STATE OF UTAH
NATURAL RESOURCES
Oil, Gas & Mining

May 15, 1987

Re: State Permit and Decision Document, Boyer Mine, ACT/043/008,
Folder No. 3, Summit County, Utah

Summit Coal Company
Boyer Mine
PRO/043/008
Summit County, Utah

FIGURE 1

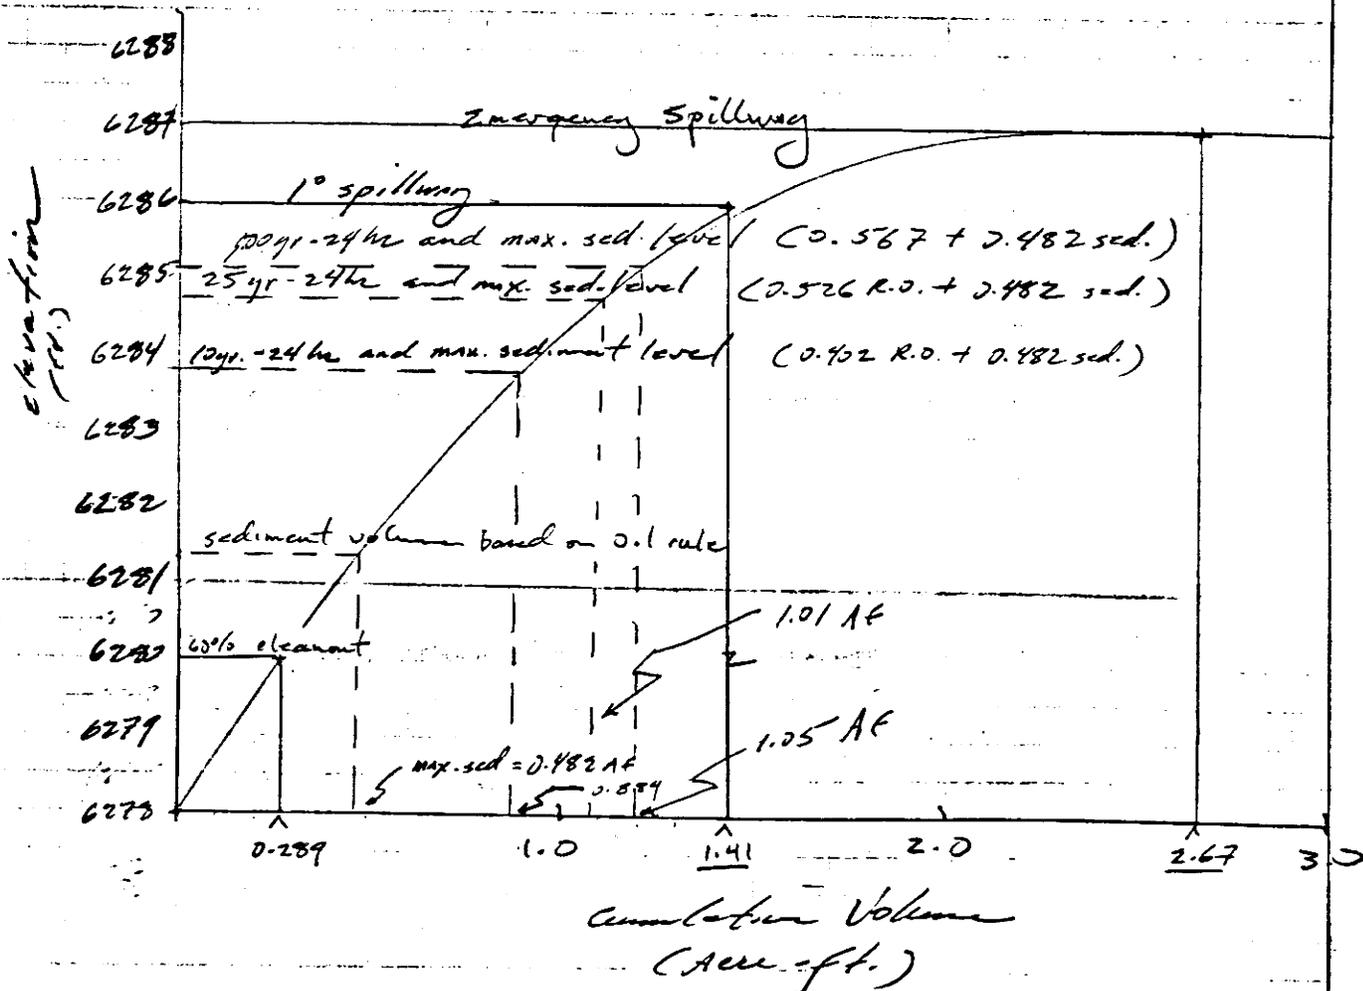
Based upon plate 7-2, the regulatory authority calculated a stage-volume curve for the proposed pond. The curve that is presented in Figure 1 demonstrates that the pond is significantly oversized with respect to ability to contain the runoff volume and required sediment volume from the disturbed area. The volume of the pond is sufficient to contain the 100-yr, 24-hr precipitation event runoff and the design sediment volume at an elevation one foot lower than the primary spillway. UMC 817.46 only requires containment of the expected runoff from the 10-yr, 24-hr precipitation event and design sediment volume.

I. Stage-Volume Curve:

∴ approve all Boyer values are conservative.

3. Within 30 days of permit issuance, the permittee shall provide correct assumptions and peak flow values for design flows used for the design of the sedimentation pond.
4. Within 30 days of permit issuance, the permittee shall submit plans to the Division for the emergency spillway for the sedimentation pond. These plans should incorporate the 25-yr, 24-hr design event, a spillway lining of adequately sized riprap, a filter blanket design, and an adequately sized energy dissipator.
5. Within 30 days of permit issuance, the permittee shall submit to the Division a commitment to inspect the sedimentation pond during construction and submit certified as-built drawings of the structure. These must be conducted by a registered professional engineer.
6. Within 30 days of permit issuance, the permittee shall provide a correct Plate depicting the location of sampling station SS-7.

FIGURE 2

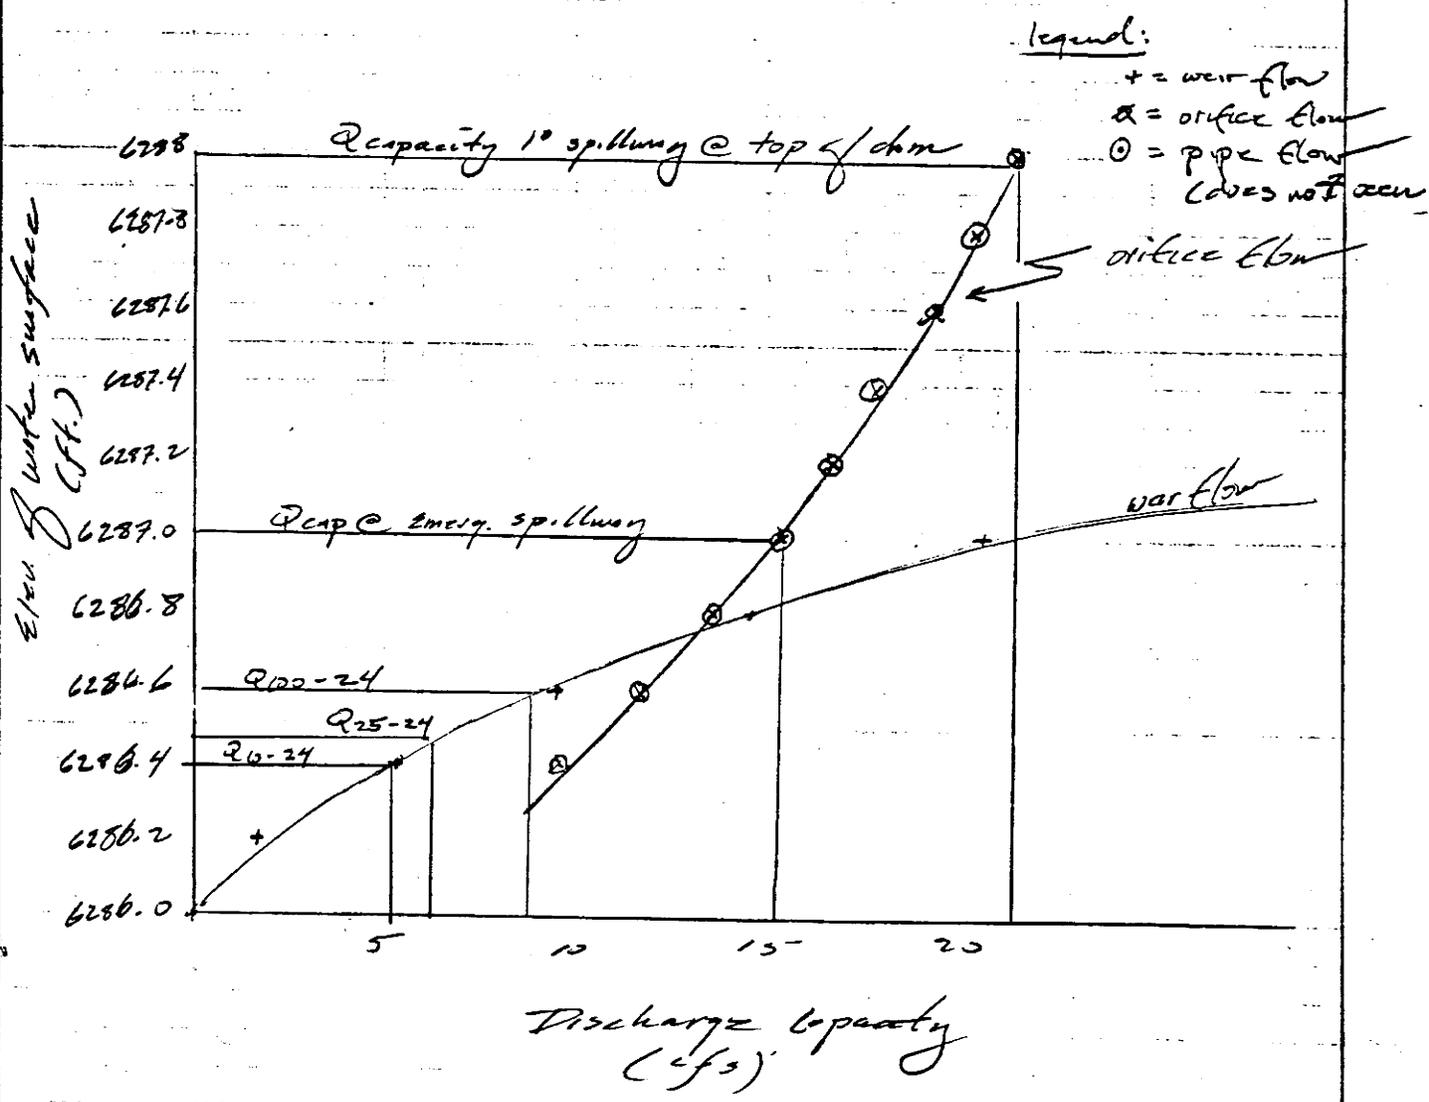
A technical analysis of the spillway system was conducted utilizing hydraulic theory applicable to drop inlet type structures. Values of weir, orifice, and pipe flow were calculated for incremental changes of head of 0.2 feet. The resulting stage - discharge curve is presented as Figure 2. From this curve we can conclude that the spillway is significantly oversized. The primary spillway has the capacity to discharge the 100-yr, 24-hr event (8.77 cfs) at an elevation of 6286.6 ft. which is 0.4 ft. below the elevation of the emergency spillway. Results of the peak flow evaluations can be found in the discussion of UMC 817.43. The applicant's presented values for the peak flow for the disturbed area are in error. Stipulation UMC 817.46-(3)-RPS will correct this deficiency and ensure compliance with this regulation.

II Step-Discharge Curve:

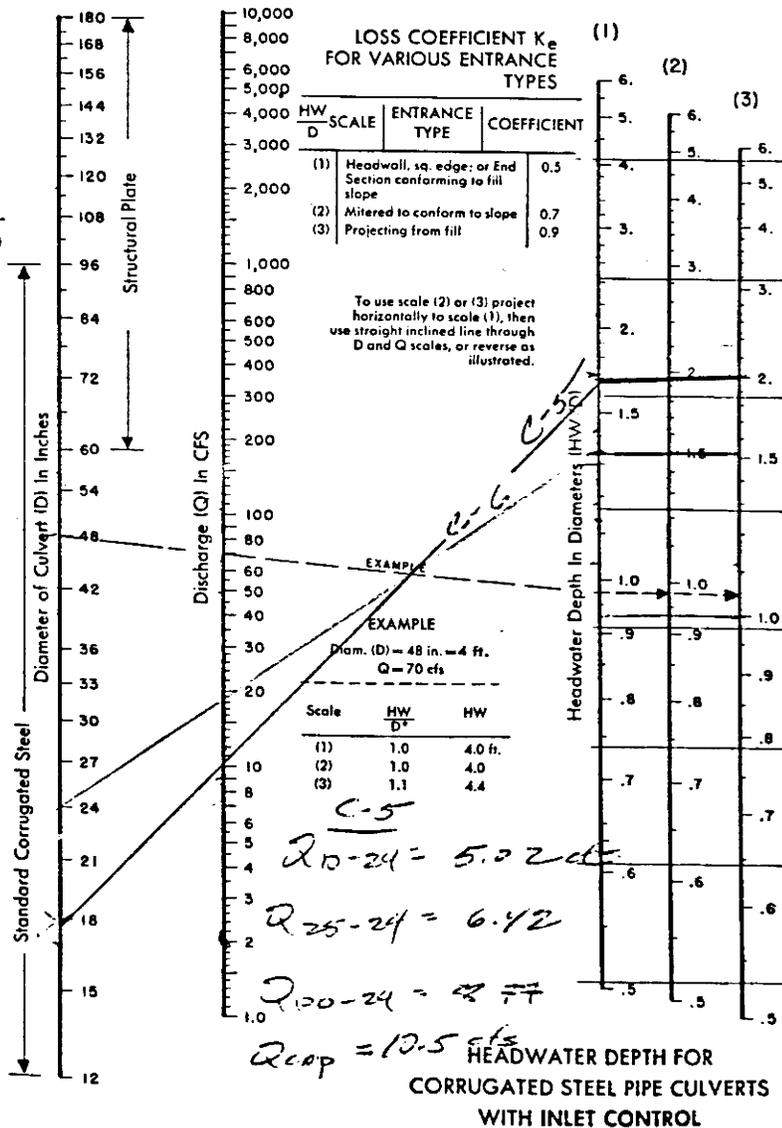
1.4"
C-6
AWH = 3'
HW/D = 1.5
C-6
7.0 cfs
12.36 cfs
16.6 cfs
Q_{cap} = 19 cfs

C-5: use peaks for DISTR. area (pad) note 40-1
C-6: use C-5, and add 40-2 and 40-3
* HIGHWAY DRAINAGE leaves @ culvert crossing highway.
Fig. 4-18. Inlet control nomograph for corrugated steel pipe culverts. The manufacturers recommend keeping HW/D to a maximum of 1.5 and preferably to no more than 1.0.
